**Re: 2/13/24 Valley Water Board Agenda Item 8.1. Update on the Pacheco Reservoir Expansion Project.**

## February 13, 2024 Valley Water Board Agenda Item 8.1. Update on the Pacheco Reservoir Expansion Project Sierra Club Comments on Presentation Slides

### Presentation Slide 2 Needs Addressed by Pacheco Reservoir Expansion Project

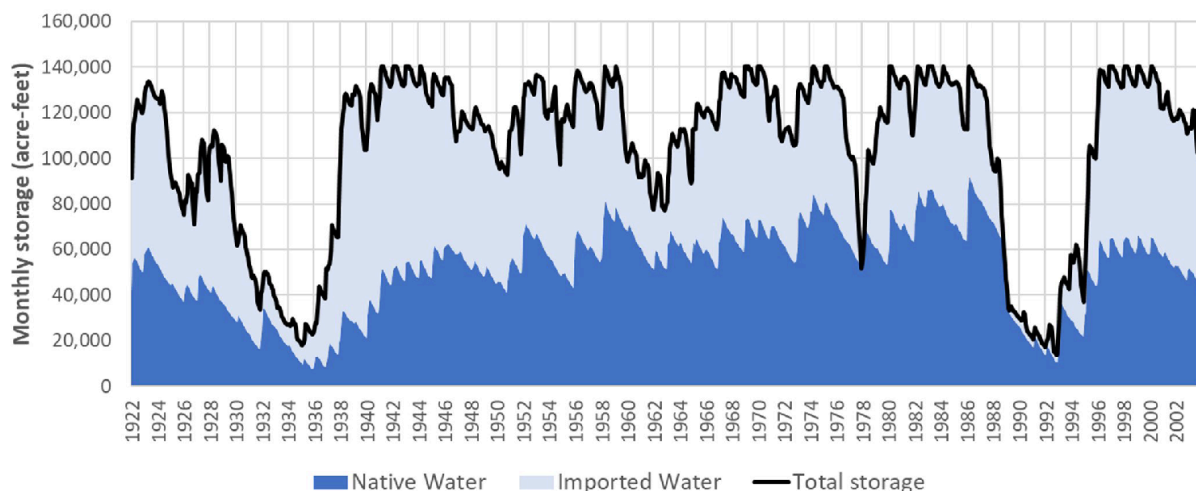
- Restore Federally Threatened Steelhead Fish Habitat
  - There is no guarantee that the proposed additional flows and restored habitat will result in any recovery of the Steelhead. Operational parameters for the 35,000 acre-foot habitat storage reserve need to be provided in order to have a meaningful discussion of overall reservoir operations.
- Improve Delta Watershed Wetlands
  - More information is needed to quantify the benefits of providing water in one specific water year type (below normal).
- Eliminate Water Quality Issues from San Luis Reservoir
  - This graphic should be updated to say “reduce” rather than “eliminate” to align with slide 12.
- Reduction of Downstream Flooding
  - As requested in previous public comments, reduction of flooding has not been identified as a benefit of this project and should not be included here.

### Presentation Slide 7 Long-Term Storage of Expanded Reservoir

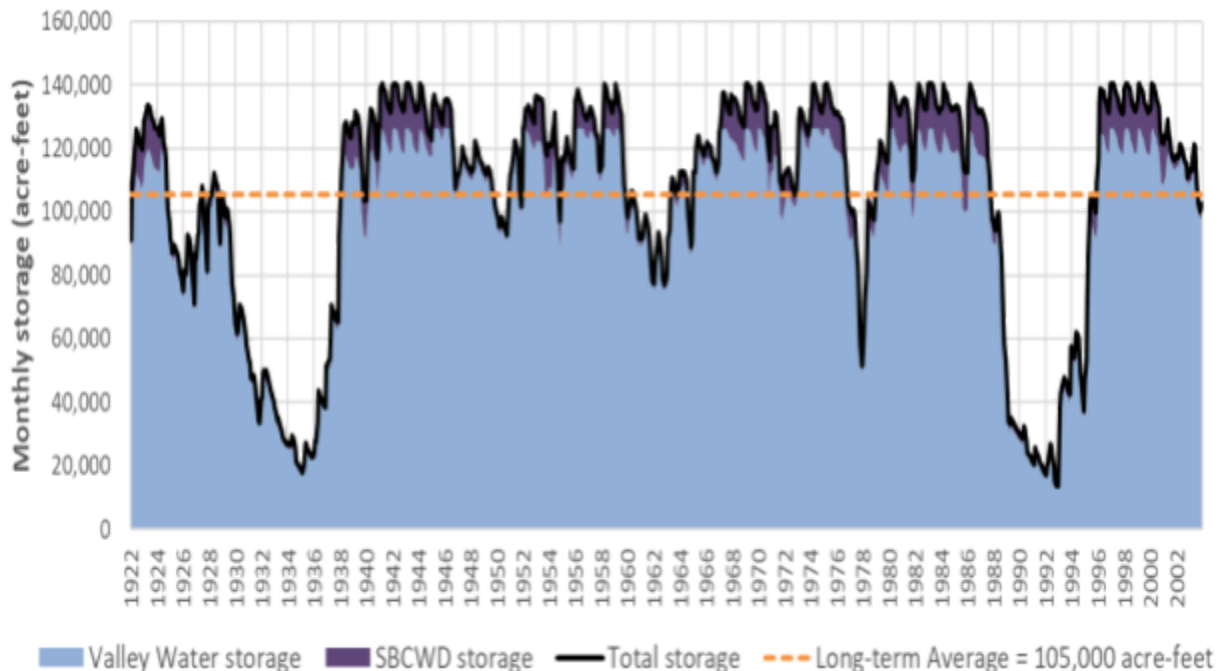
- The graph should show data through 2022 to enable analysis of more recent conditions.
- The graph does not show water stored for fish. This part of project operations should be included.
- The graph does not show water moved through Pacheco Reservoir to alleviate water quality issues in San Luis Reservoir. This part of project operations should be included.

### **Presentation Slide 10 San Luis Reservoir Low Point Water Quality Issues**

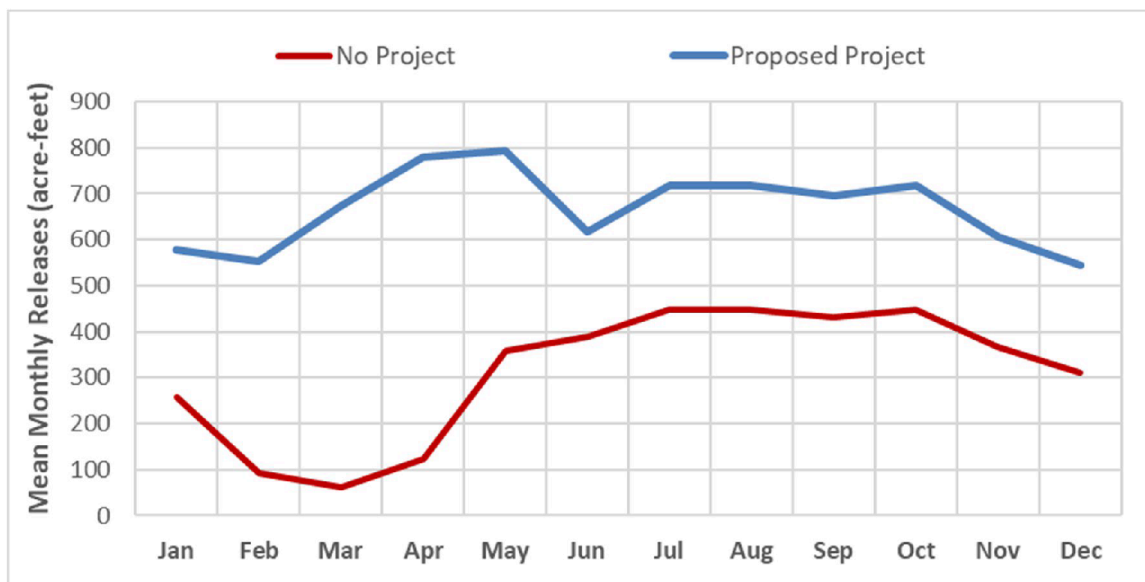
“Spikes in taste and odor measuring times normal levels, which cause problems in today’s domestic supply”

- These water quality issues have been mitigated to date using other methods. These other methods are surely more cost effective than building this new dam.
